Docket No.: 50-410

APPLICANT: Niagara Mohawk Power Corporation (NMPC)
FACILITY: Nine Mile Point Nuclear Station Unit 2
SUBJECT: SUMMARY OF MEETING HELD WITH NIAGARA MOHAWK POWER CORPORATION
ON JUNE 9, 1984, ON EMERGENCY PREPAREDNESS

REVIEW COMMENTS ON NINE MILE POINT UNIT 2
EMERGENCY PLAN

FIGURE 1

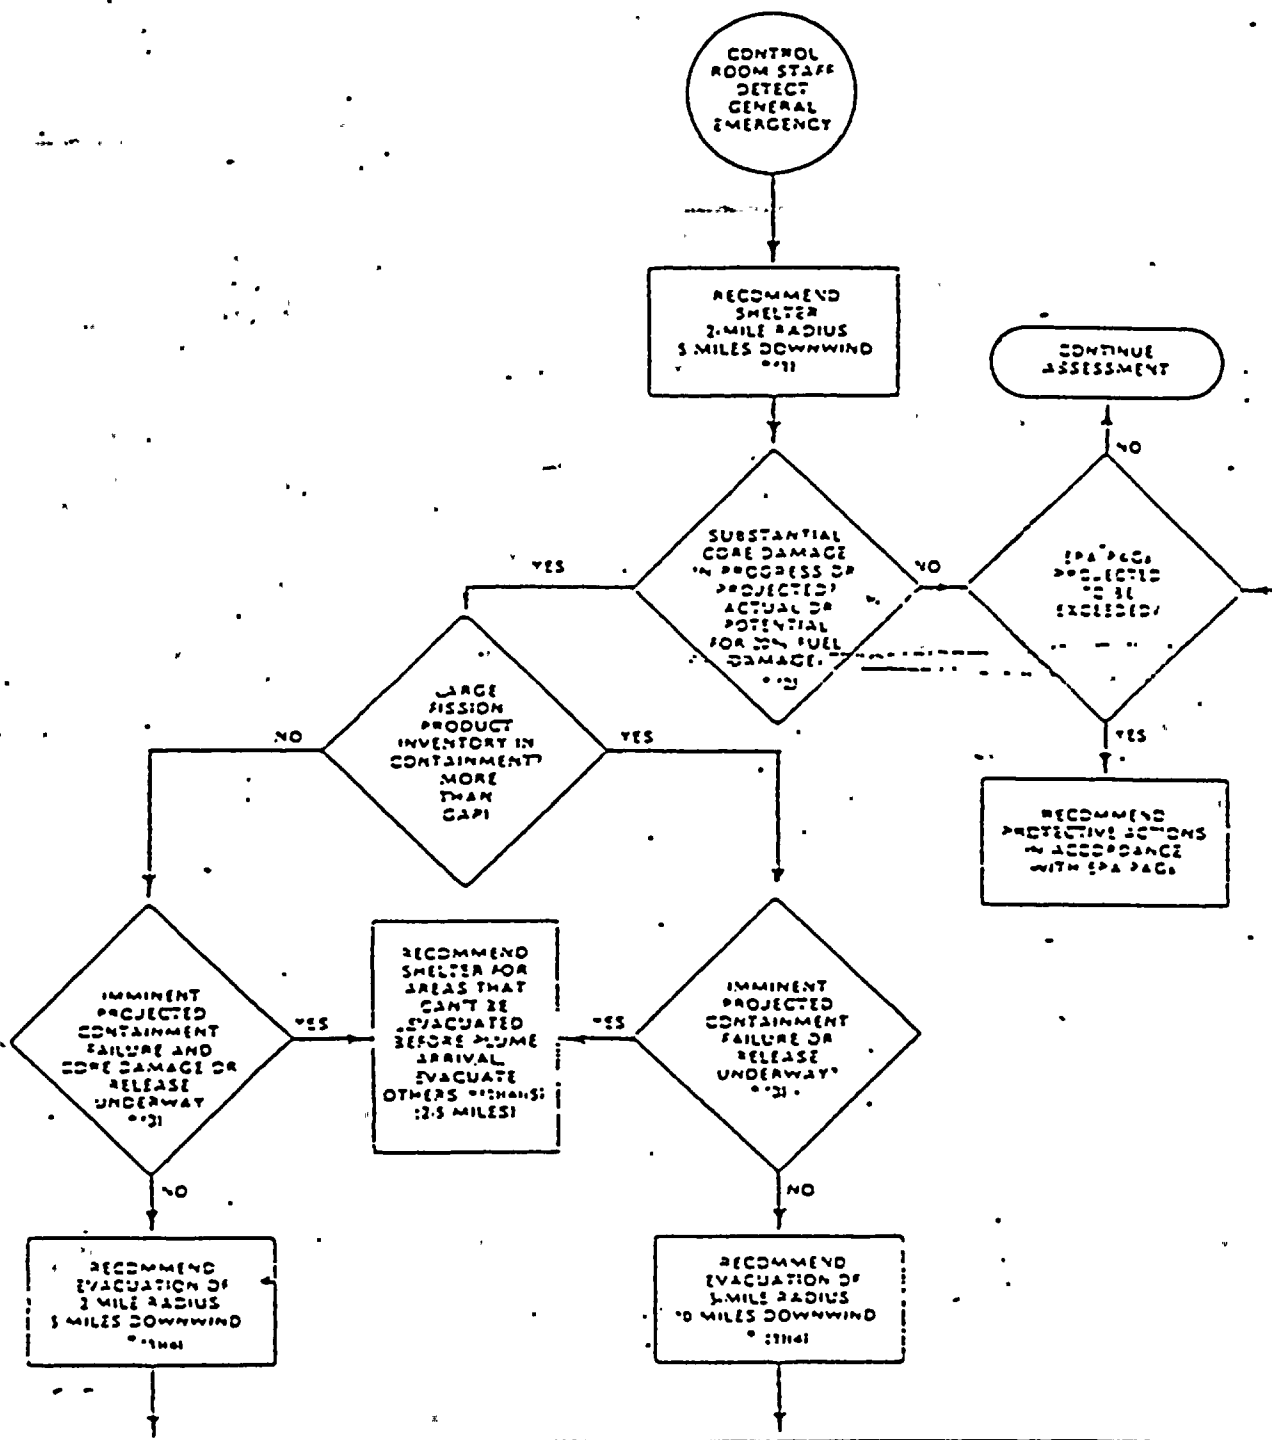
Initiating Conditions 1, 2, 3, 4, 6, & 7 The applicant does not have adequate EALs for any of the applicable NUREG-0654, Appendix 1 General Emergency Initiating Conditions. It is suggested that the applicant refer to the flowchart in Attachment 1 for guidance in developing appropriate protective action decisions.

NMPC to provide explanation and clarification of chart
